PORSCHE-DIESEL

SERVICE BULLETIN #2

Subject: Miscellaneous Technical Information for Dealer and Customer

Former type
Ancien type
Tipo viejo

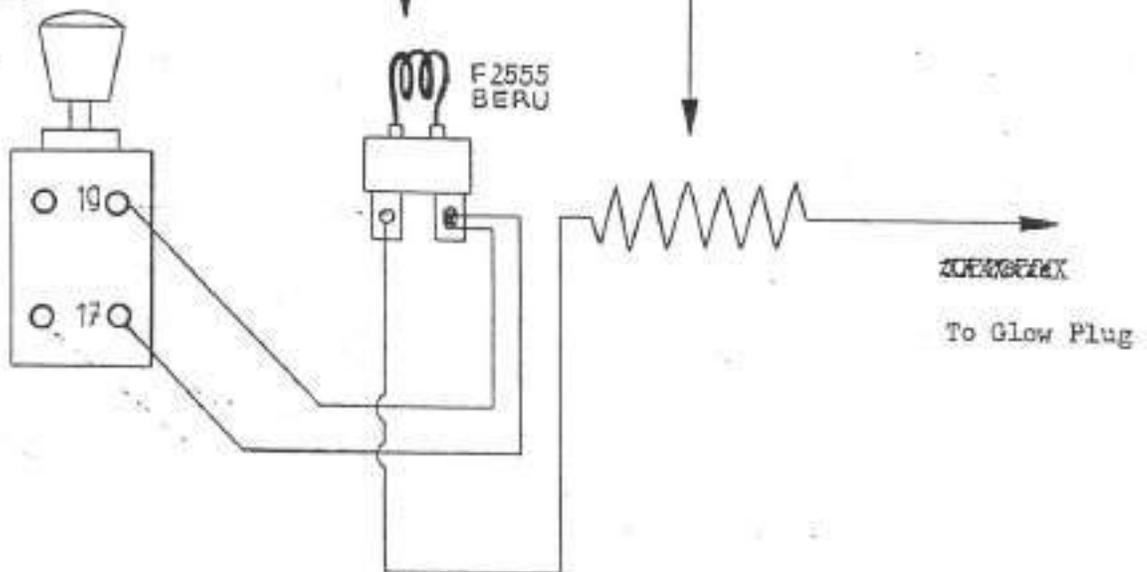
From the attached wiring diagram you will see the former and the wiring system. We ask you to change the corresponding connections on the glow control according to the new wiring diagram on the following tractors:

In addition to our service circular mentioned above we went to provide some exact installing instructions for the medication of the electrical wiring system at the glow control.

Try which one of the black wires develops sparks when brought into contact with yellow -black wire (19). This wire (17) is to be connected to the glow control as single wire, the other one together with yellow-black wire.

Be careful that the wires are not mixed up, since, in this case the glow control will remain out of the circuit and the glow plug will be overstressed.

New type
Nouveau type
Tipo nueva
